## Product / Process Change Notification (PCN)

**PCN #:** PCN\_ConDCPJ\_20210921  
**Affected Series:** WE-ConDCPJ -  
 694106402002 - 694108402002

**PCN Date:** June 21, 2021  
**Effective Date:** September 21, 2021

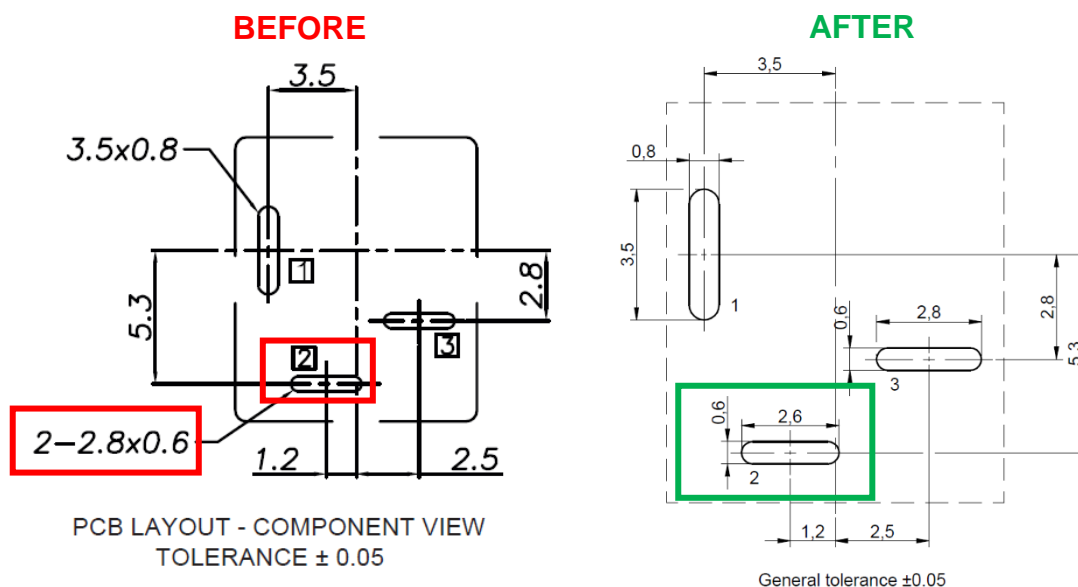
Because of a database mismatch, Würth Elektronik is correcting the PCB layout for this reference.

This is a datasheet correction only.

There will be no change in form, fit, function, quality or reliability of the product.
